Bennett Building Inc.**Job Name :** Boaz Retail Center**COR Number** COR-9**Job Number :** 22-114**Description :** Structural Support Load For Gym Book Store**Date:** 4/18/2023

Change Order Request

Work performed: Additional Roof Structure per drawing S1.2 & S1.3

RENOVATIONS
TO
BOAZ RETAIL CENTER
FOR THE
CITY OF BOAZ
BOAZ, ALABAMA

S1.2

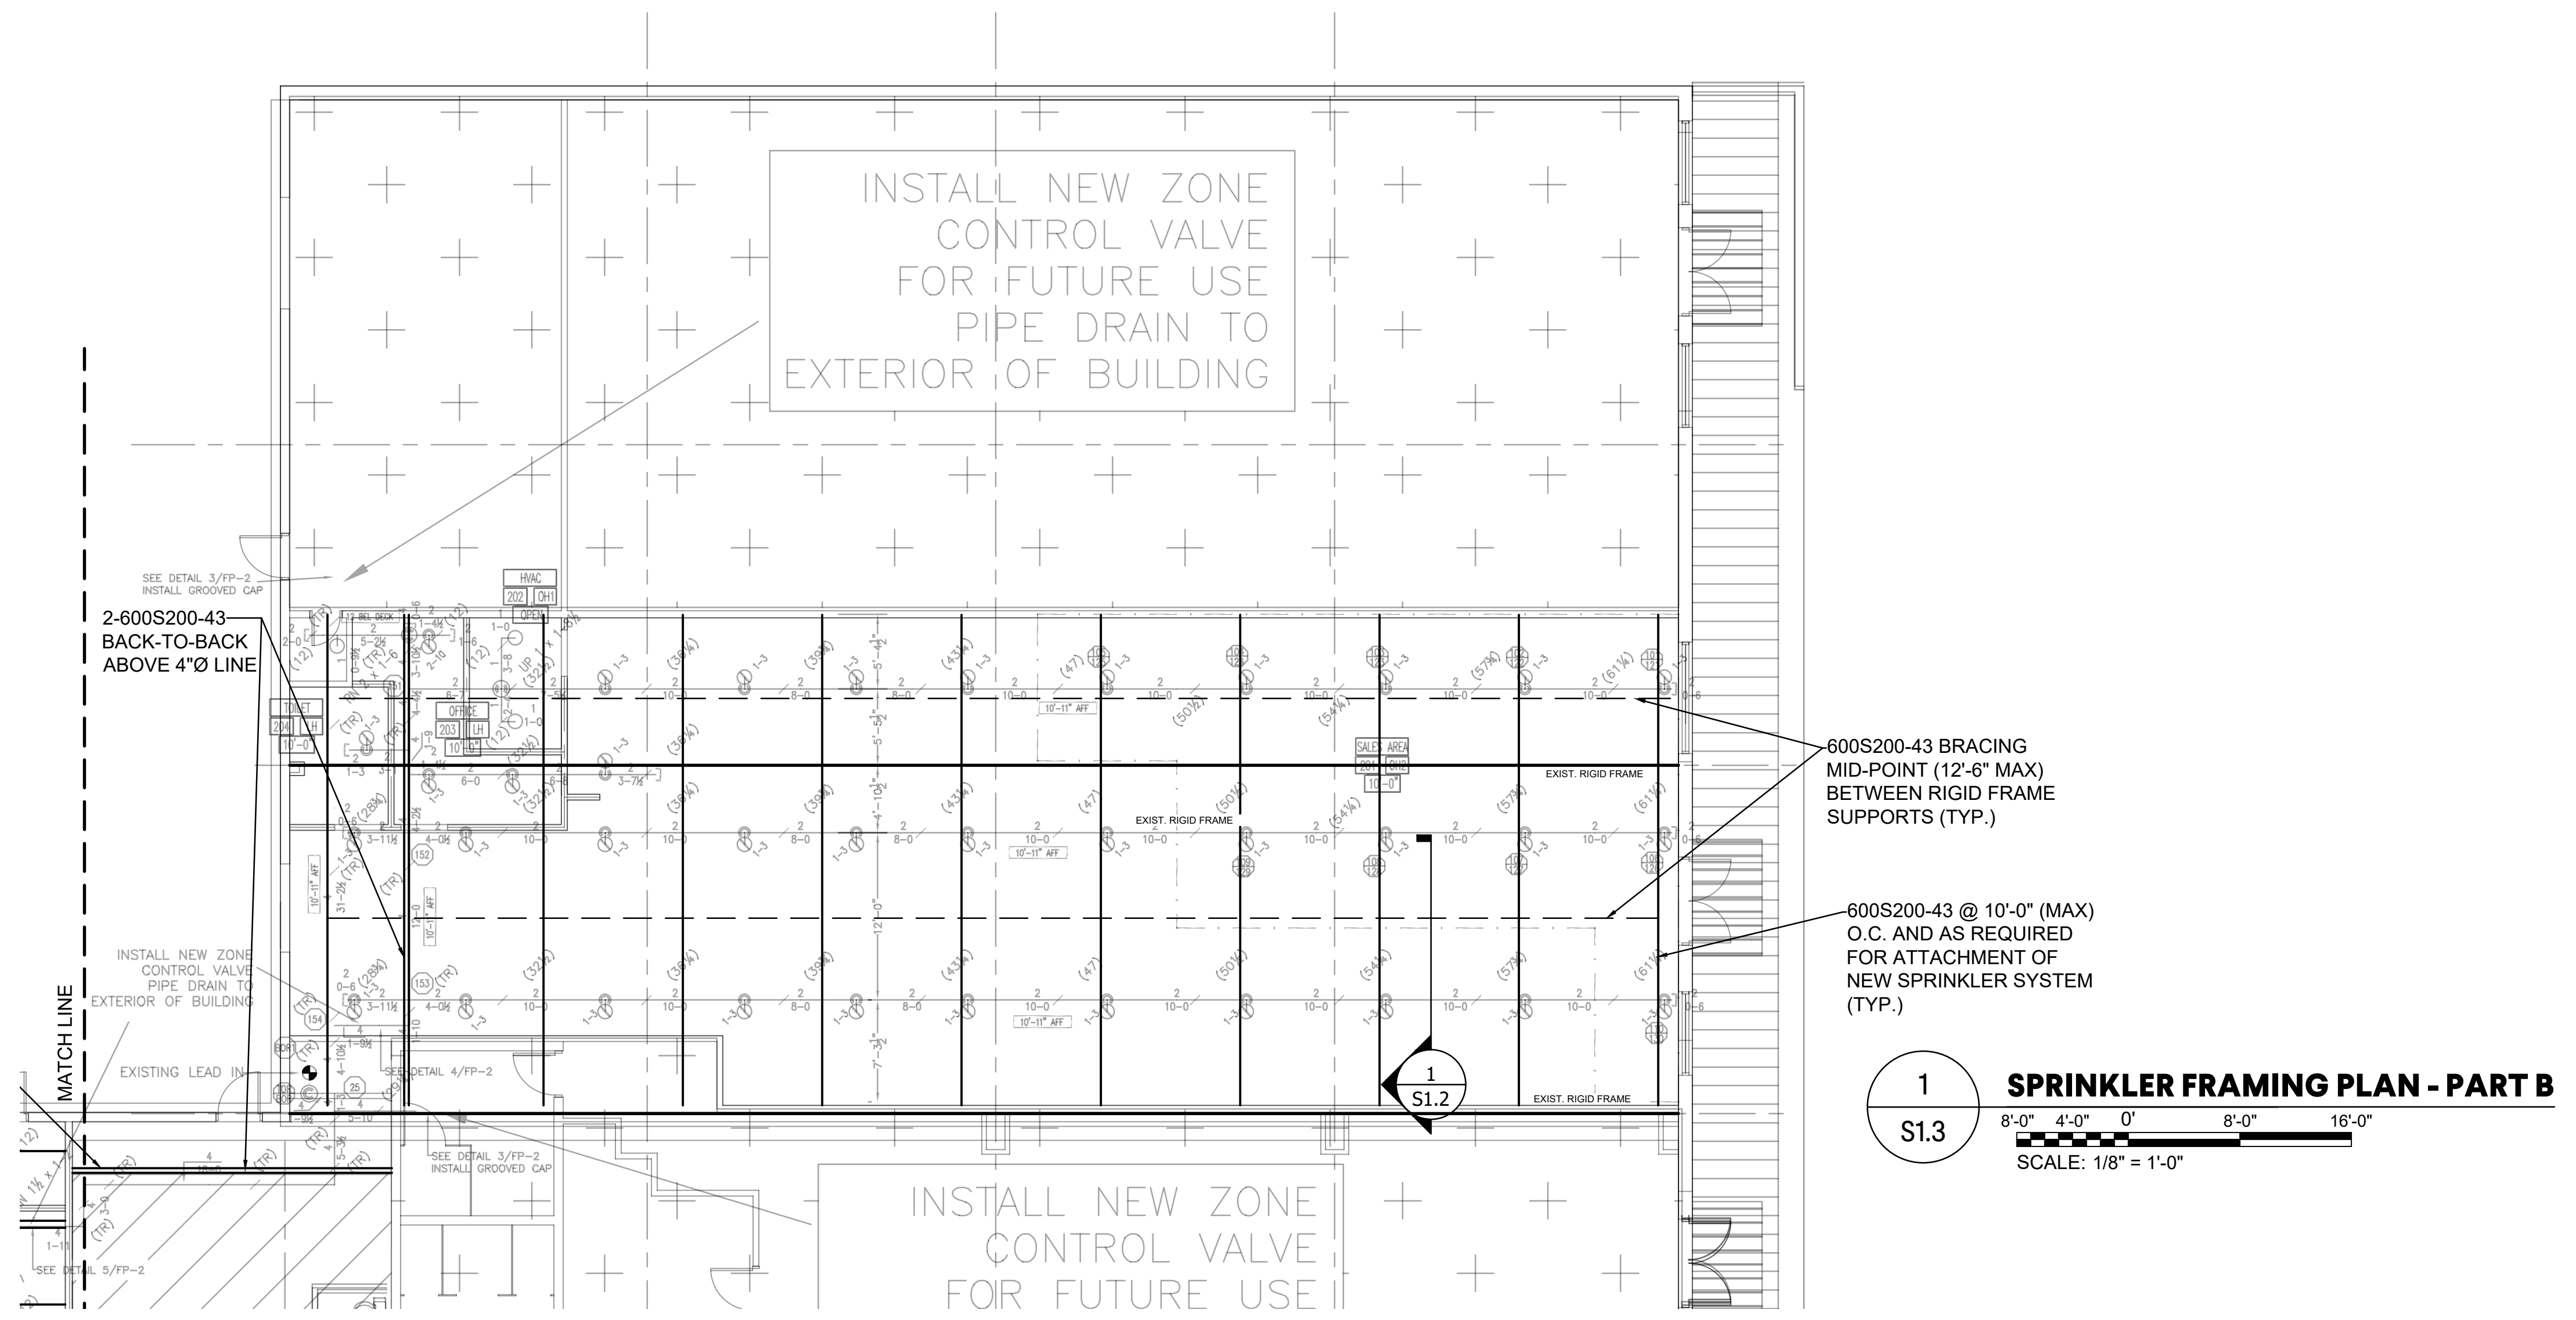
600S200-43 BRACING
MID-POINT (12'-6" MAX)
BETWEEN RIGID FRAME
SUPPORTS (TYP.)

600S200-43 @ 10'-0" (MAX)
O.C. AND AS REQUIRED
FOR ATTACHMENT OF
NEW SPRINKLER SYSTEM
(TYP.)

2-600S200-43
BACK-TO-BACK ABOVE
4"Ø LINE

2-600S200-43
BACK-TO-BACK
ABOVE 4"Ø LINE

LINE OF EXISTING PURLINS
EXISTING RIGID FRAME
16 GA. FRAMING CLIP W/
(2) #10 TO PURLIN AND
(2) #10 TO EXISTING RIGID
FRAME
CFMF FRAMING AS
INDICATED ON PLAN FOR
SUPPORT OF NEW
SPRINKLER SYSTEM
BRACE NEW FRAMING
MID-SPAN (12' MAX) AS
INDICATED ON PLAN
